DOCKETED	
Docket Number:	24-OPT-01
Project Title:	Perkins Renewable Energy Project
TN #:	257953
Document Title:	Perkins CEC Data Request Response Set #1 for the Opt-in Application 24-OPT-01 Part 1
Description:	Response Set #1 for the CEC Data Request for the Perkins Renewable Energy Project Opt-in Application 24-OPT-01
Filer:	Emily Capello
Organization:	Panorama Environmental, Inc.
Submitter Role:	Applicant Consultant
Submission Date:	7/23/2024 11:31:00 AM
Docketed Date:	7/23/2024

**California Energy Commission
Perkins Renewable Energy Project
CEC Data Request Response Set #1 for the
Opt-in Application 24-OPT-01**

CEC Data Request Response Set #1 for the Opt-in Application 24-OPT-01

Figure 11 Authorizations and Leaseholders on BLM Lands Mapbook Sheet 5

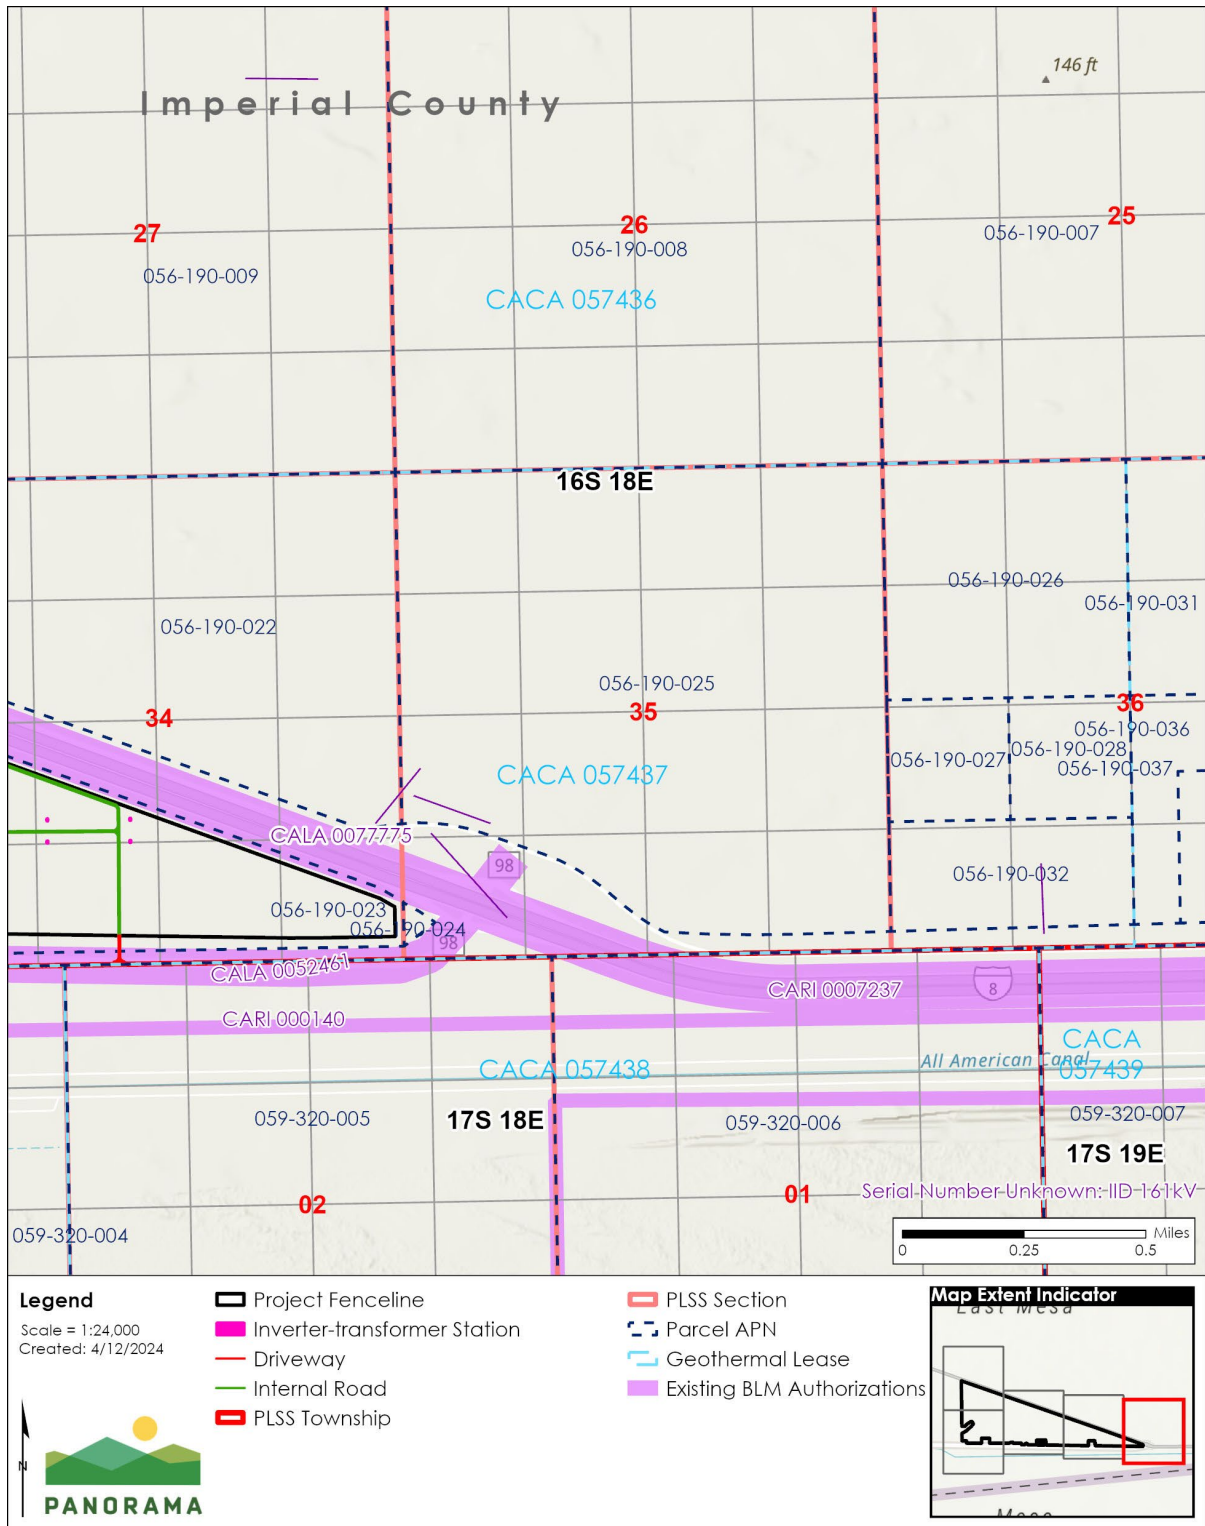
DR PD-4: Please identify and label the county on each map (Figures 6 to 11), please identify and label the county-international border on applicable maps; and please identify and label the township, range and section(s) in each figure title (Figures 7 to 11).
